KIDNEY CENTERS OF AMERICA JSP14-70

Consideration at the request of Whitehall Real Estate Interests for approval of the Preliminary Site Plan and Stormwater Management Plan. The subject property is located in Section 17 of the City of Novi on the west side of Beck Road along Grand River Avenue in the OSC, Office Service Commercial District. The current submittal, Kidney Centers of America, includes a 7,621 square foot Dialysis area and 2,484 square foot Office space along with associated parking, loading and landscape on a 1.89 acre site that will be under lease.

PLANNING REVIEW

SUBJECT: Kidney Centers of Michigan, JSP14-0070, Traffic Review of Preliminary Site Plan, PSP14-0195

PROPOSED SITE PLAN - ENLARGED -

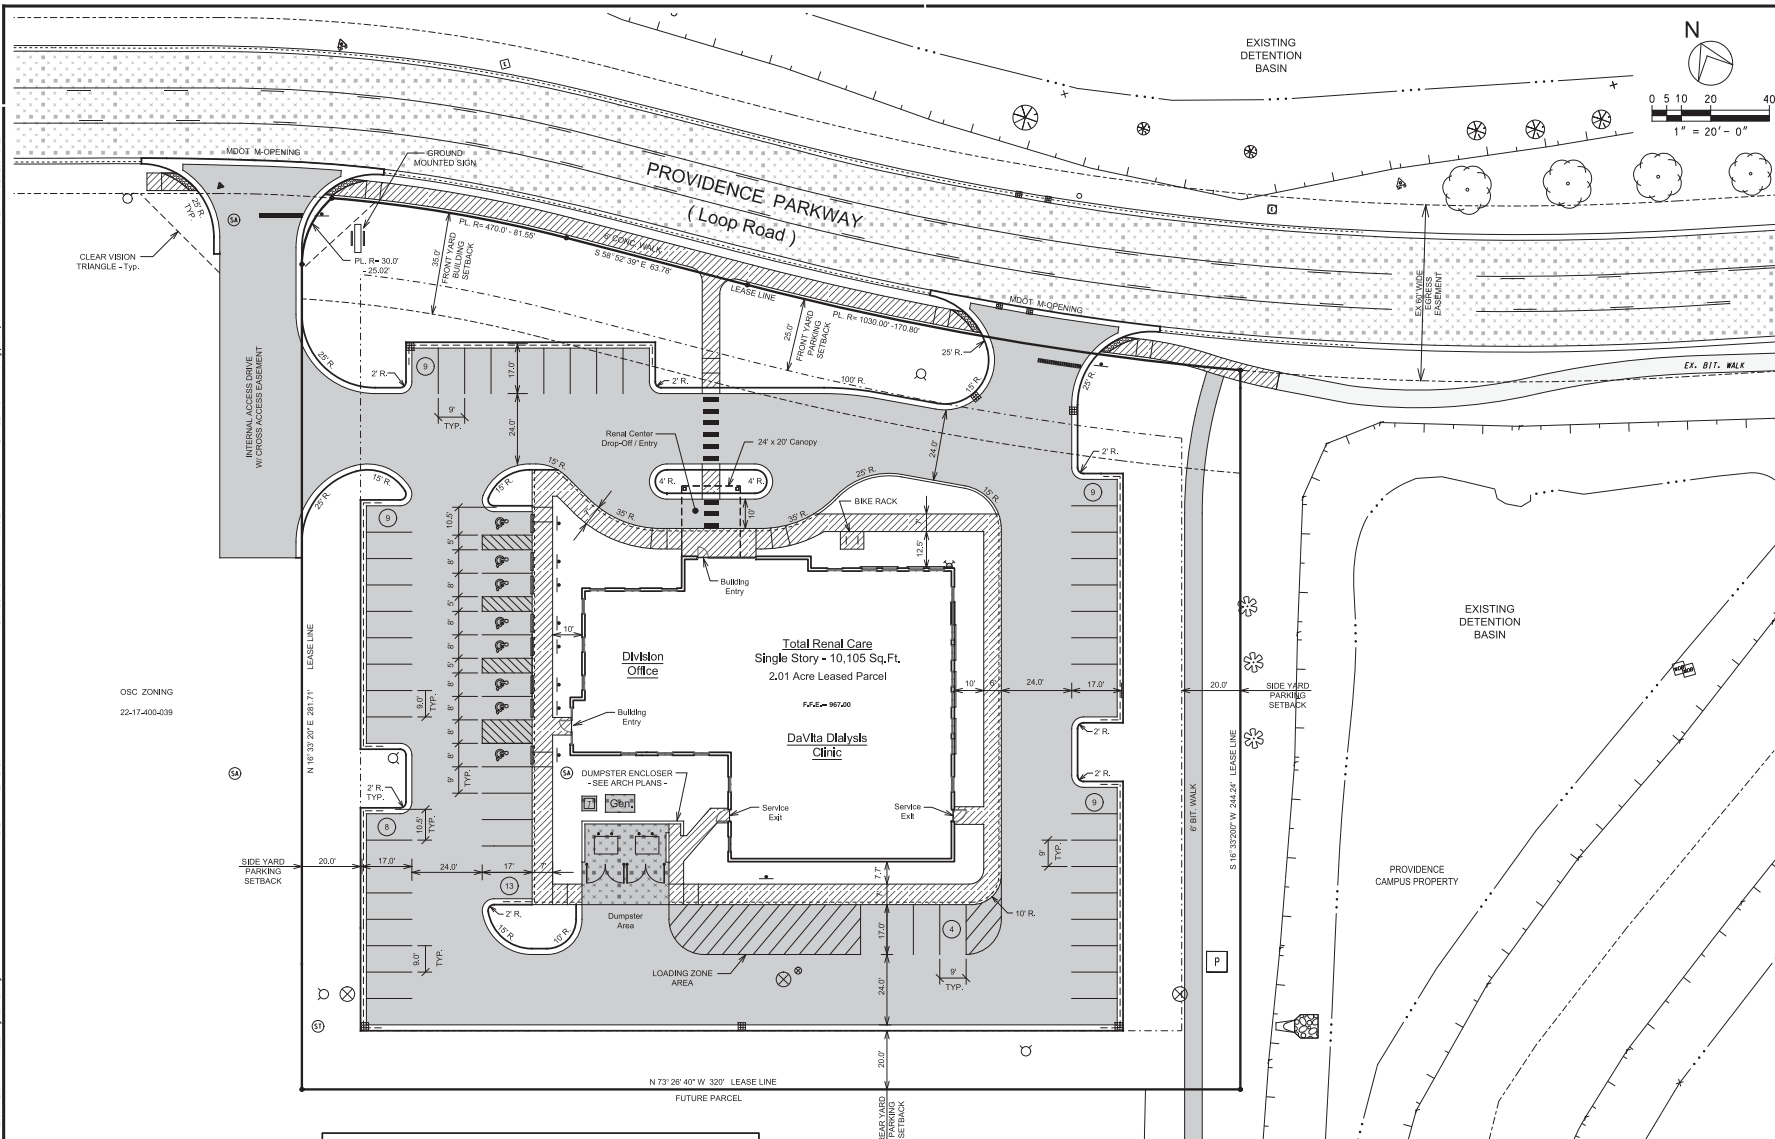
The Preliminary Site Plan shows parking in the front yard and the site plan describes a property that is slightly less than two acres. **The applicant may choose to increase the boundary of the subject property to include a minimum of two acres, or may seek a variance from the Zoning Board of Appeals to allow the proposed parking to remain in the front yard.** Staff is in support of either alternative, and has no objection to the parking spaces in the front yard, as it appears that the Kidney Center will be a part of a larger, phased development.

Regarding item #1 of the Plan Review Report: It is the intent of the applicant to not seek a variance. It is proposed that the site be increased to two acres. Refer to the attached revised site plan exhibit dated 12/4/14 for reference.
